ENGINE, TURBINE ASSEMBLY - STEADY-STATE OPERATION AVOIDANCE LIMIT

SB RR300-A-72-018

SERVICE BULLETIN

Torque Setting Limitation
FIG. 1

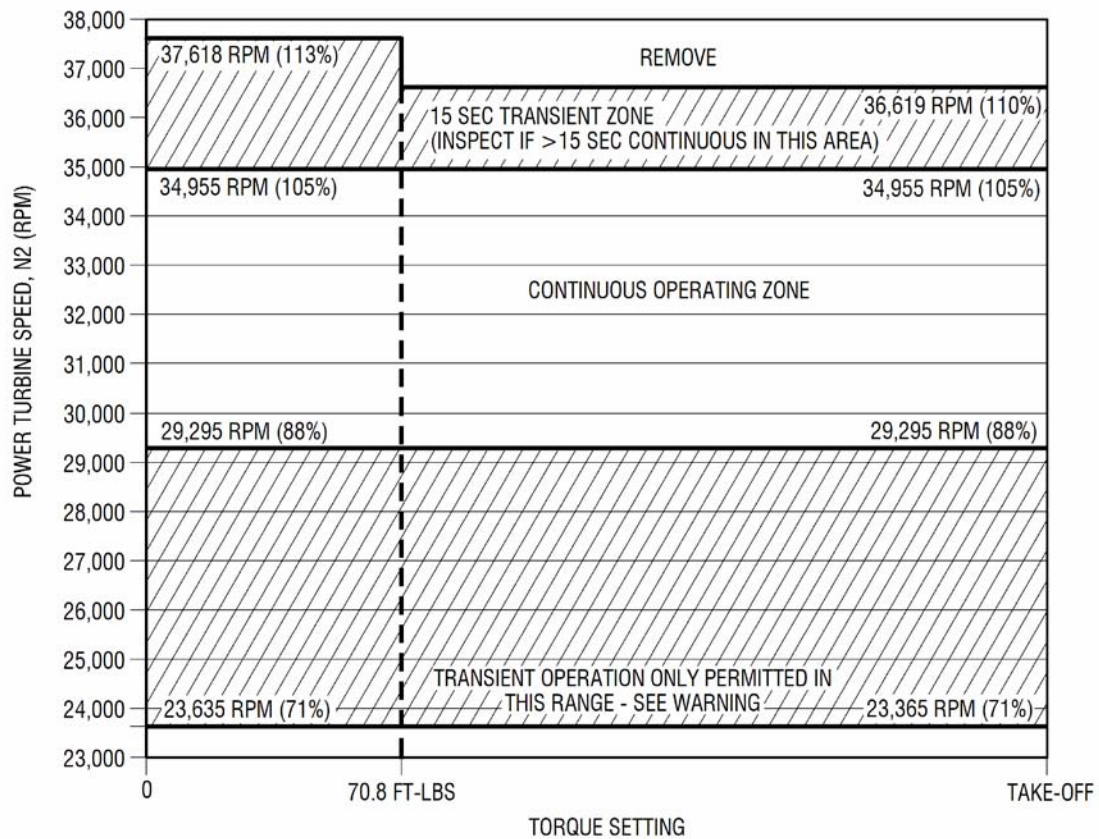
A. Ground Idle (GI) to fly rotor run-up Keep Out Zone: 71% to 88% Np.

- (1) Transient operation only is permitted in this zone for rotor run-up; time in the zone must be minimized as far as possible. A target torque of 40–45% must be used for rotor acceleration between Idle (GI) and Fly.

Ref. FIG. 1

NR(NP) % limitations
FIG. 2

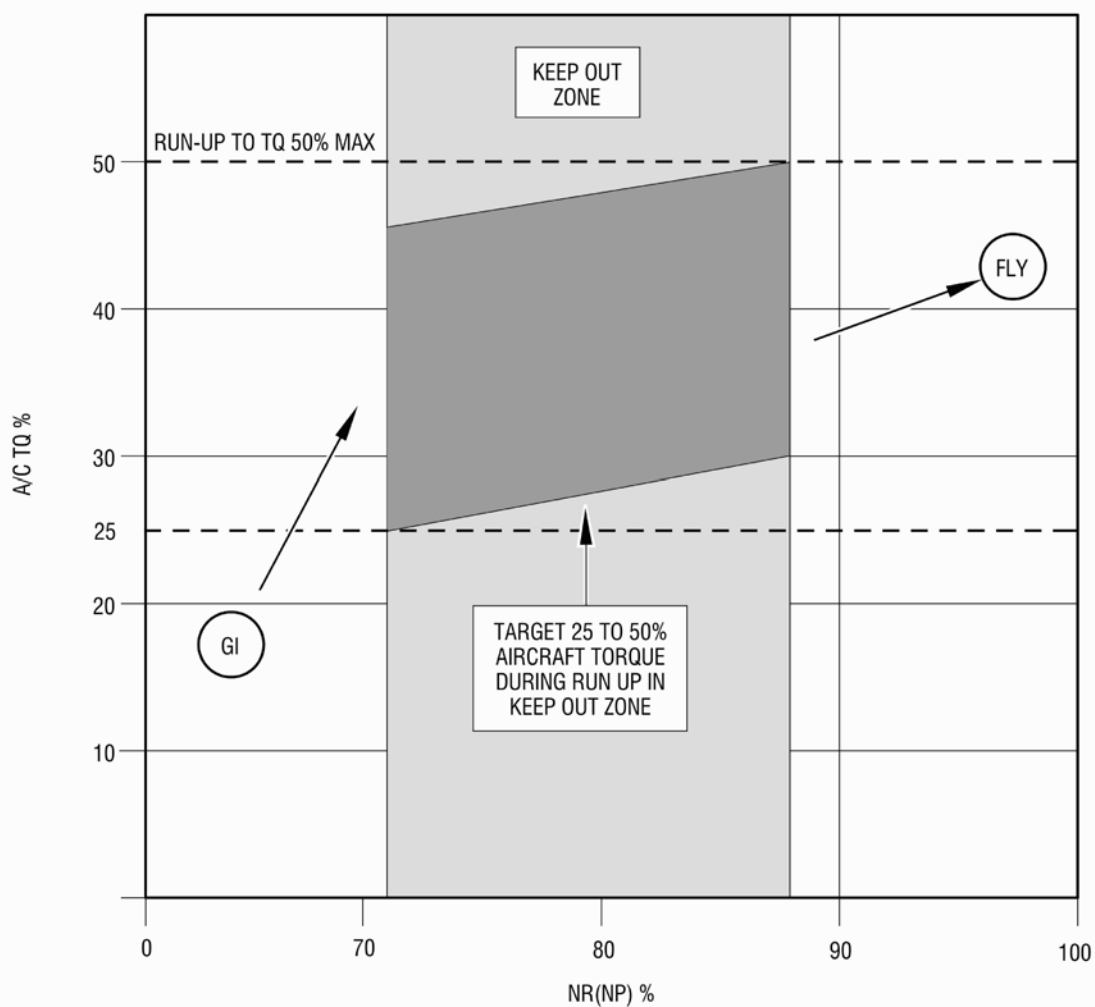
Ref. FIG. 2

- (1) Transient operation only is permitted in the keep out zone 71% to 88% Np. Any other operation in the band is prohibited, in particular continuous operations (any dwell of more than 1 second) must be avoided.

- (2) Each event between 105% and 110% N2 that meets the exceedance criteria must be logged in the appropriate section of the Engine Log Book. Excursions are only recorded in the EMU when the duration of any one event is more than 15 seconds. The EMU light will illuminate after 15 seconds above 105% N2.
- (3) Record the maximum speed exceedance value and the date in the turbine component record card.
